# PERMIT

SEWAGE DISPOSAL SYSTEM

SUBDIVISION Small Ridge LOT 4 ROAD 14612 Triadelphia Mill Road

RE: **Variance Approval**  
14612 Tridelphia Mill Rd.  
Dayton, MD 21036

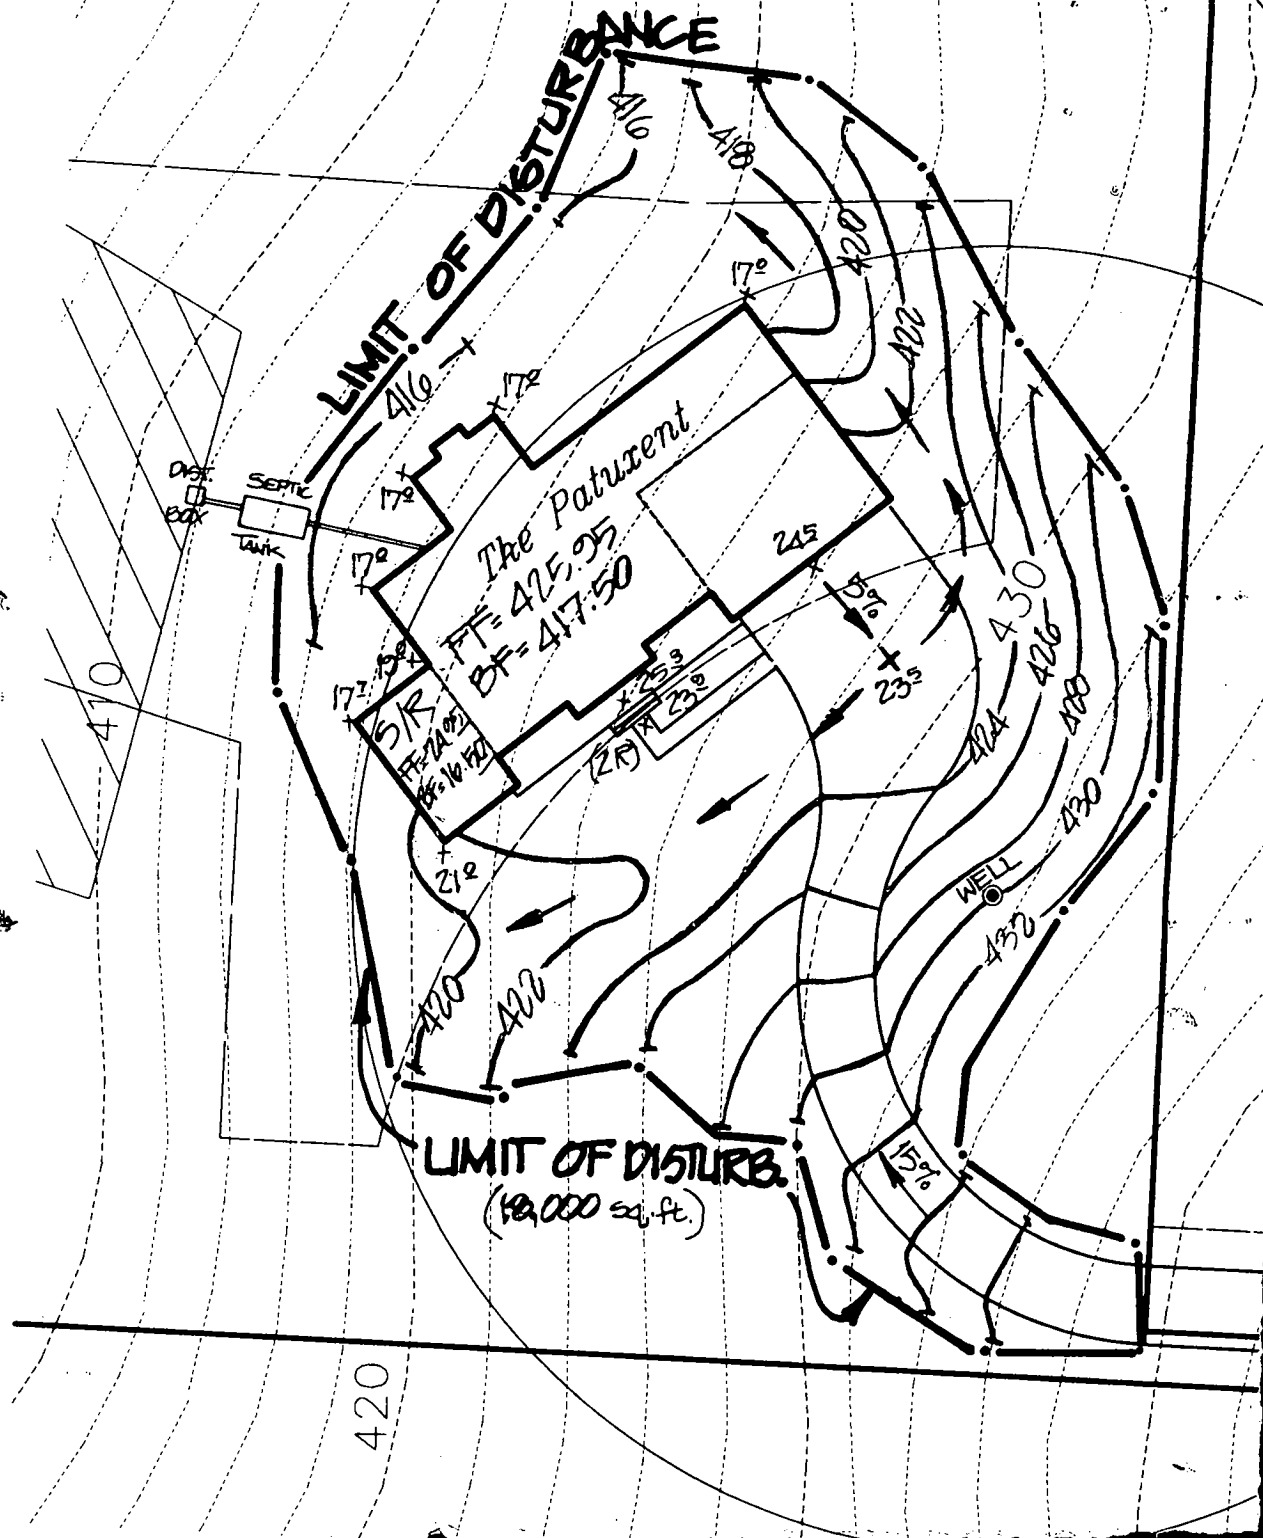
REMARKS: 9-27-99 install 3 - 80'

OK to come to center of SDA & spacing between trench due to steep slope of property  
Robinson, OK to cover Tr 1-3 when lines  
Call when ready for S.T. in stallation 10/14/99 RPP Sep

2 pipe cap - No PVC conduit pipe (blue power cord - cap is Not insert protected 6/15/99)

#3 due to excessive water & sand (upheld sand for 8 times)  
10/18/99

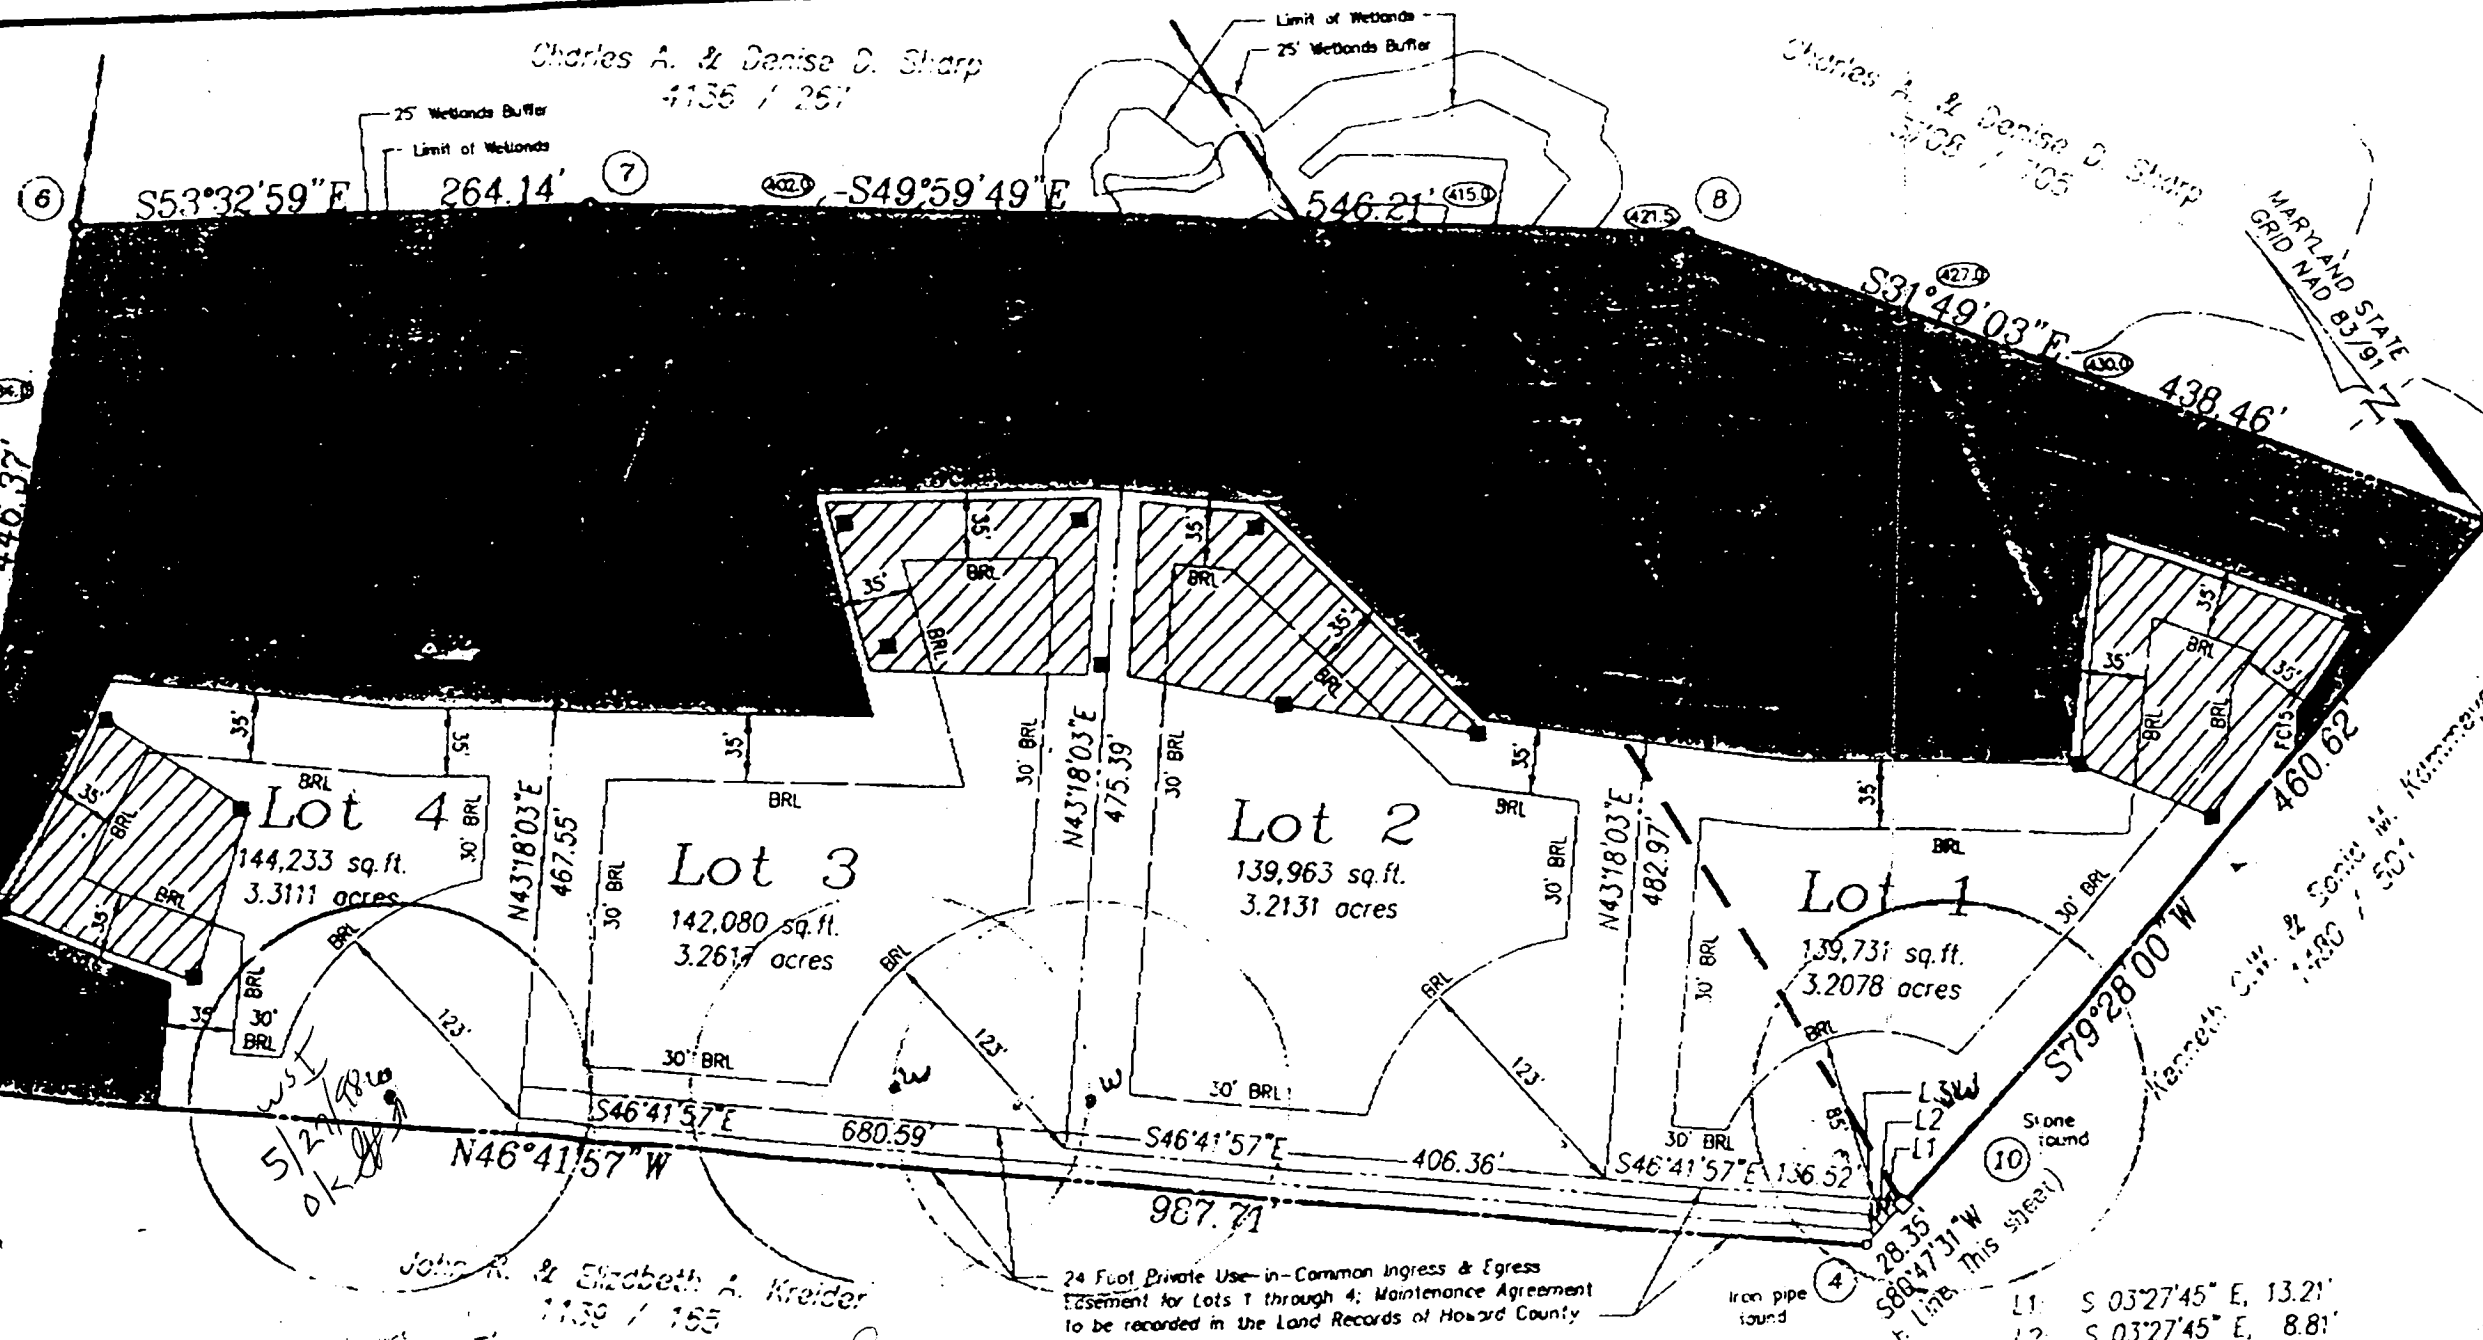
I'm writing this letter on behalf of the home owner requesting a 5' variance from the septic tank & cleanout for a deck. The original design has been altered to meet a 5' variance. The reason for the request is due to the fact that the home owner has a son who has recently returned from Iraq with serious injuries from a road side attack. The new deck is located off of the rear walk out basement. We are currently getting a permit for another area of the house that will be getting a deck as well as a wheel chair ramp. The home owner is attempting to enlarge the living area for their son as well as create an easier means for him to move around in his wheel chair.

The Department of Health has received your variance request dated November 10, 2006 for the above referenced property. This agency will grant **approval** of the variance provided that the deck is constructed with the footers of the deck no closer than five (5) feet to the existing septic tank. Approval of a building permit will be granted by this Department provided that the site plan submitted with the building permit application is consistent with the site plan approved under this variance request and the construction plans illustrate the construction of the footers in compliance with the five (5) foot setback. Any deviations from the site plan submitted with the request will be subject to further review by this Department.
